REQUEST FOR INFORMATION

NO.: RFI-088

Project Name: Webster University Interdisciplinary Science Building

Subject: Required clearance at loading dock

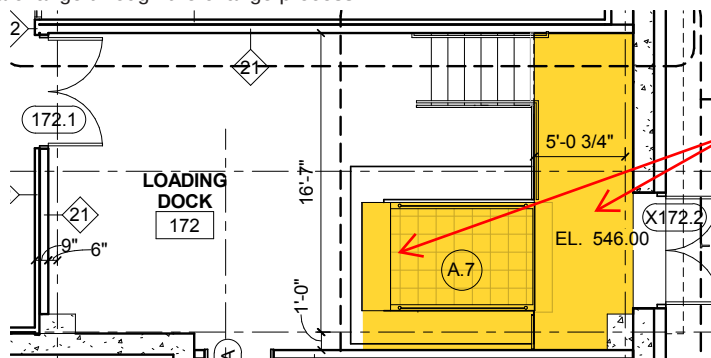
For coordination of overhead MEP what is the minimum clearance above the loading dock floor (relative elevation 86'-0") that must be maintained?

Provide min. 8'-0" clear height at the upper landing of the dock lift and above highest stop of dock lift.

Min. 8'-0" clear height at upper landing & above lift at highest stop.
